ADDENDUM NO. 11

PROJECT TITLE - PA State Police Greensburg - DNA Laboratory Facility New Building

ADDENDUM 11

MEP REVISION #1 - 11/15/2022

VERIFY SCALE section with a scale bar (1 inch = 1 foot) and a note: 'IF BAR IS NOT ONE (1) INCH LONG, ADJUST SCALE ACCORDINGLY'. Also includes a table with columns: DRAWN BY (E HOOVER), DATE (05/24/2022), DRAWING NO. (E605), CHECKED BY (S MULHOLLEN), SCALE (NOT TO SCALE), (VOLUME 1 OF 1).

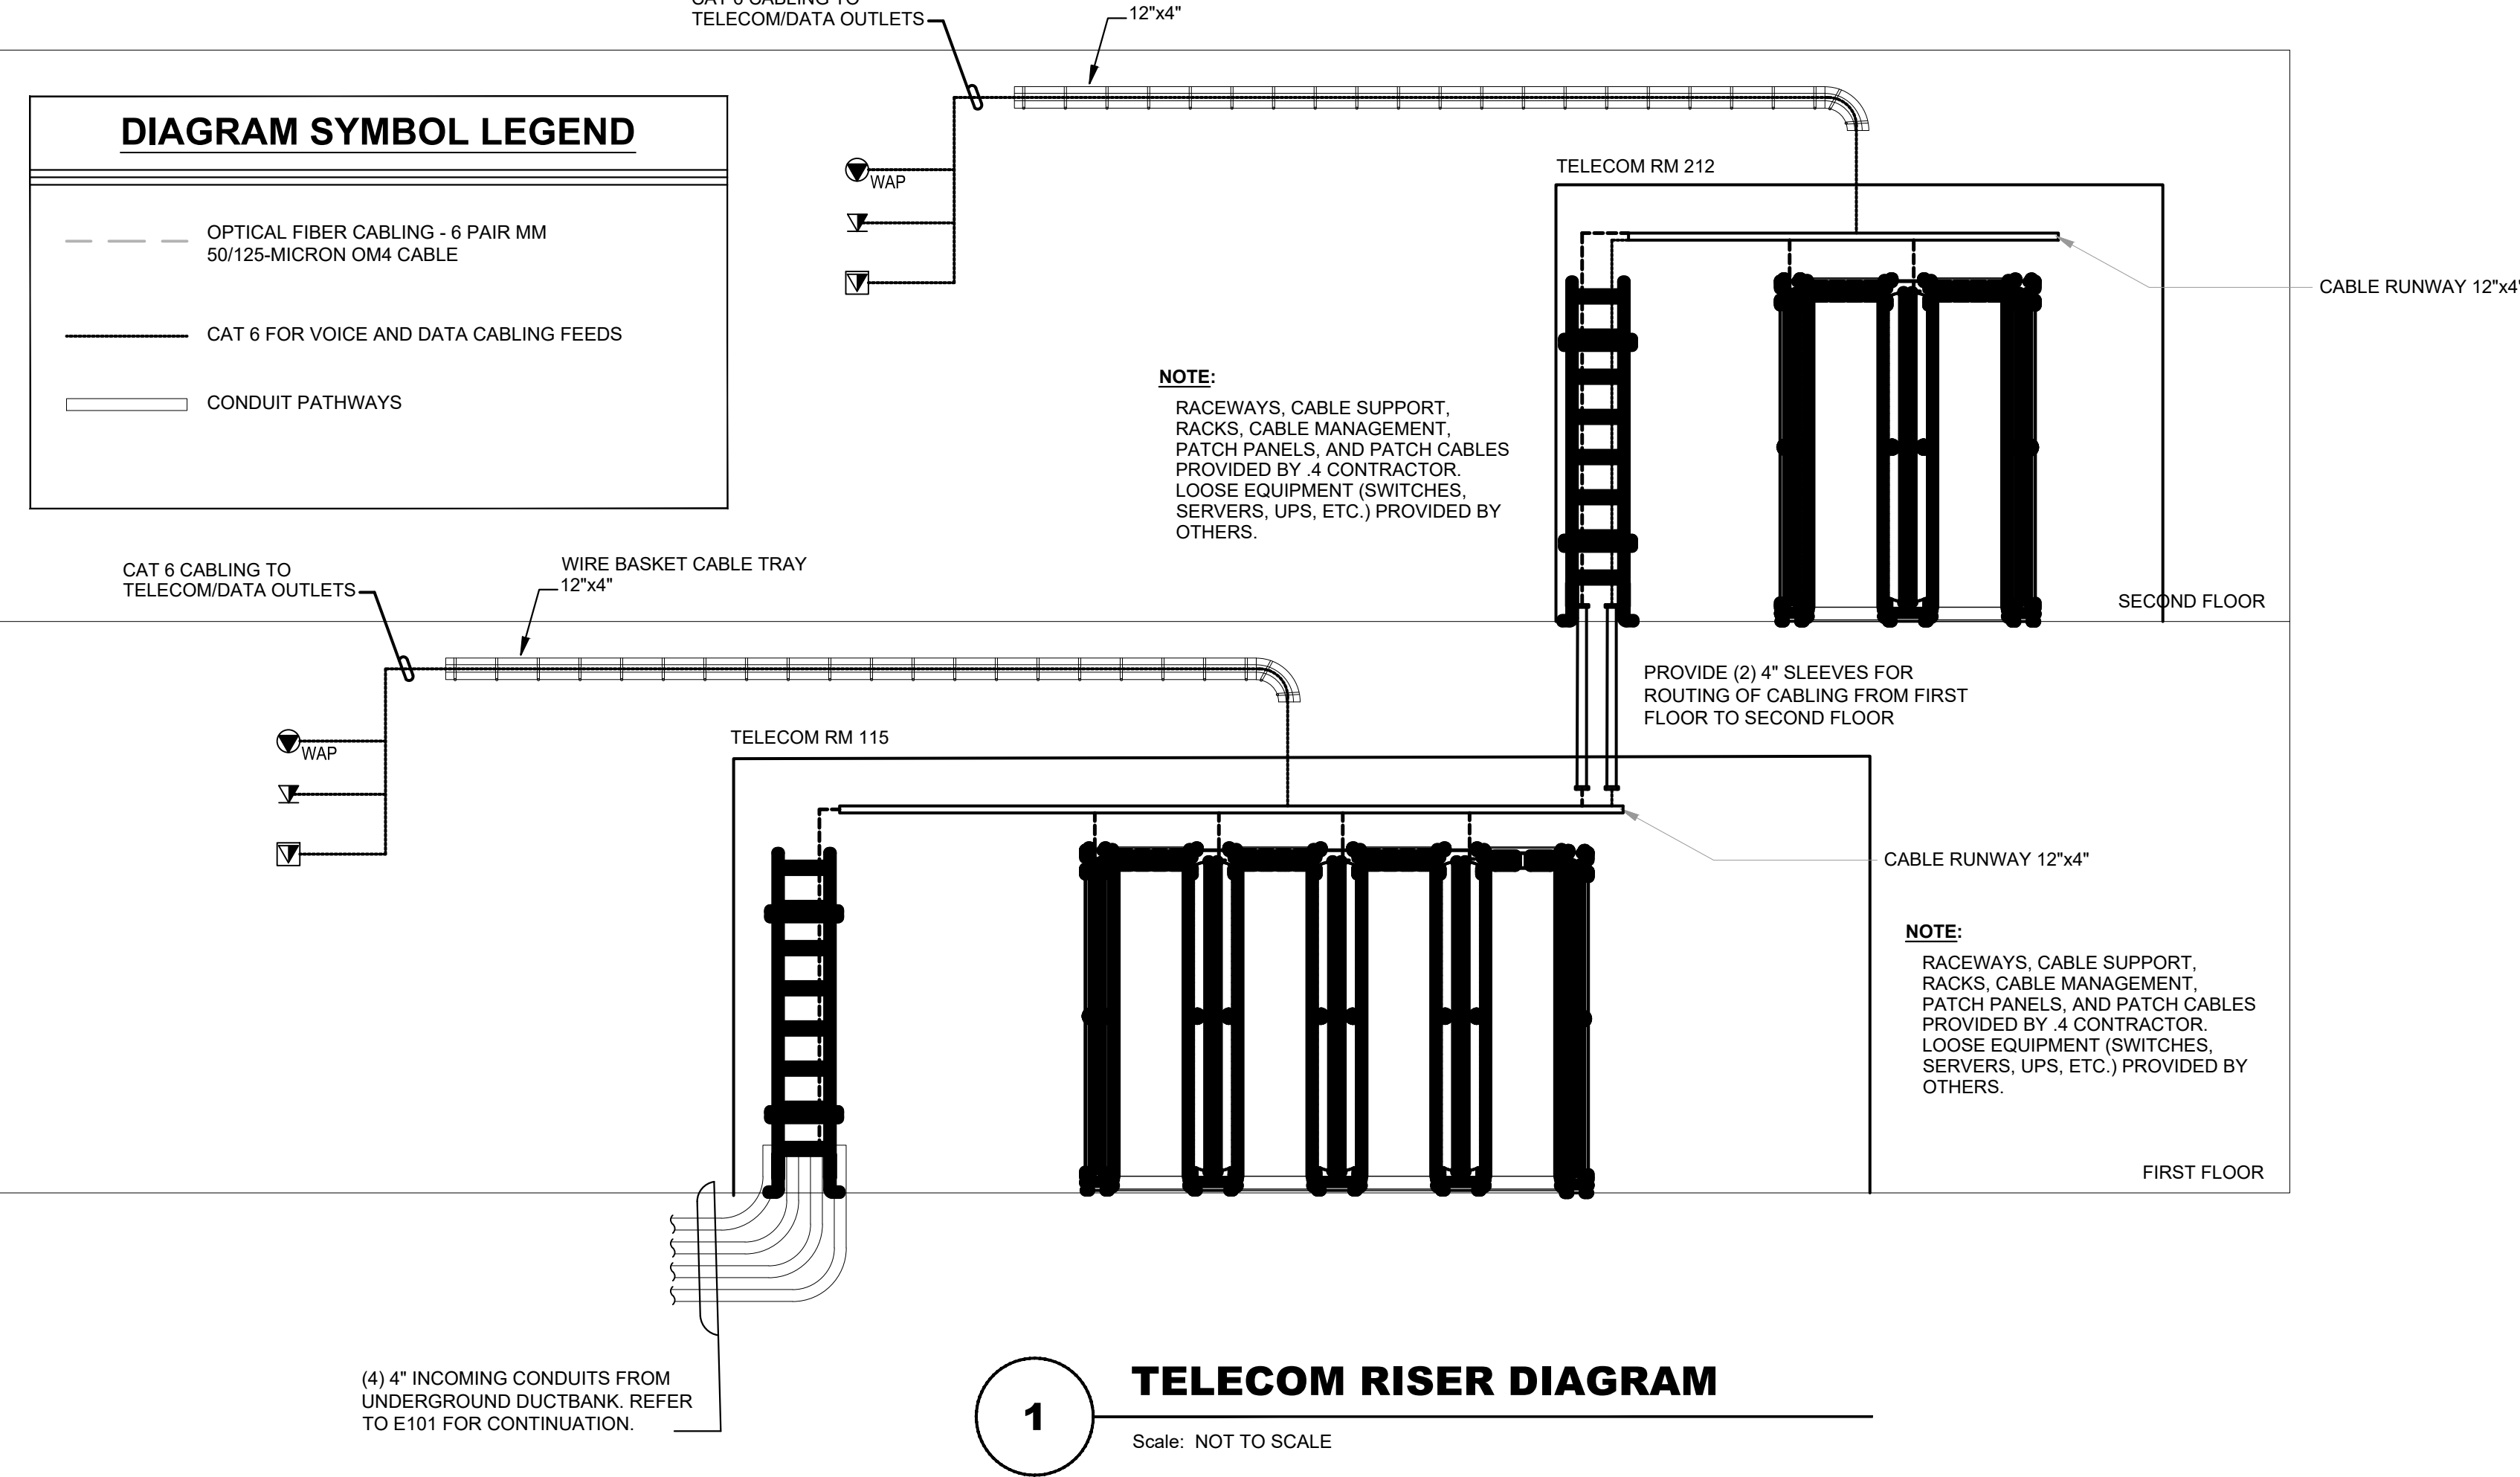
.4 Contract - RFI 01	10.25.2022 01:09 PM	Jim Clark, TSB Inc. d/b/a Schultheis Electric	Floor Boxes: Can you provide a manufacture and catalog number for the floor boxes shown on drawing E111P, E114P, E111S, and E112S?	See revised sheet E605, attached to this addendum	11.14.2022

E605 - Added "Floor and Pedestal Table Box Schedule".

E605 - Added light fixture 'S1' to schedule.

DRAWN BY E HOOVER	DATE 05/24/2022	DRAWING NO. E702
CHECKED BY S MULHOLLEN	SCALE NOT TO SCALE	(VOLUME 1 OF 1)

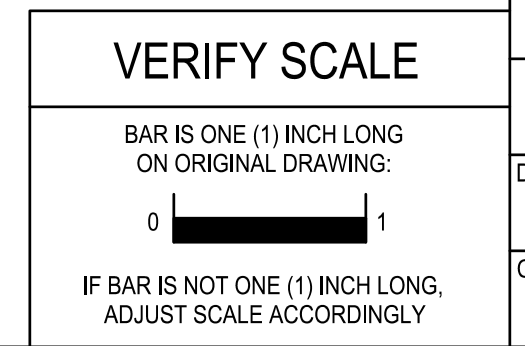
E702 - Updated Telecom Riser and Grounding Riser per client agency comments.
